## ISL78365EVAL1Z Evaluation Board User Guide Addendum and Errata

This document provides additional information and corrections to the ISL78365EVAL1Z Evaluation Board User Guide (User Guide 076) after it was published.

**FIGURE 2. ISL78365 EVALUATION BOARD CONNECTIONS**

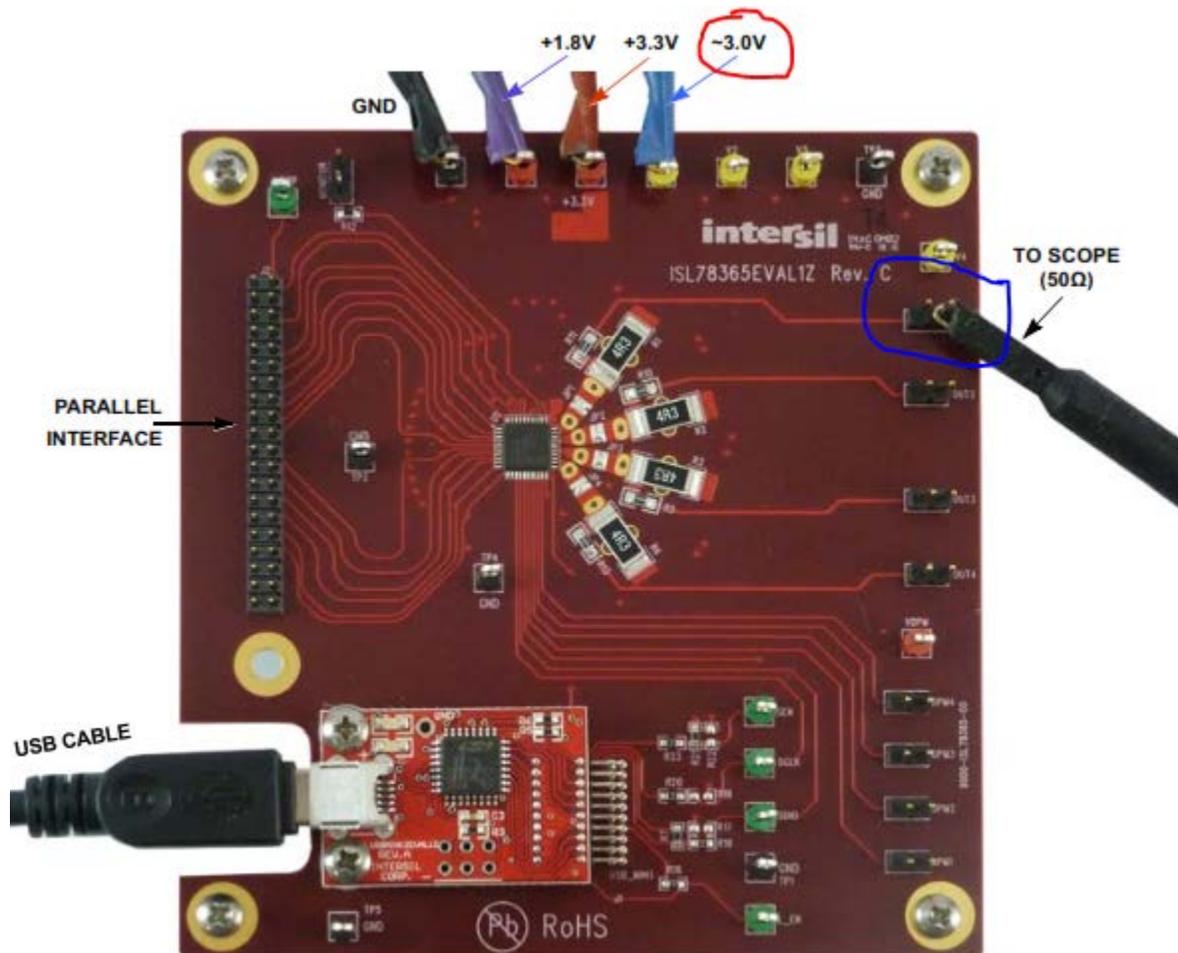
1. Figure 2 on page 2 of the User Guide shows the evaluation board. The picture shown has two errors and it is shown below with the two errors circled in red and in blue.
2. The RED circle shows a negative 3.0V. This is incorrect. The correct voltage is positive 3.0V. This voltage can be adjusted to reflect your desired laser diode voltage after you have the board and software working together.
3. The BLUE circle shows the scope probe connected to the right most pin of OUT1 header. The right most pin is the ground pin. The correct position where the scope probe should be tied to is the left pin.
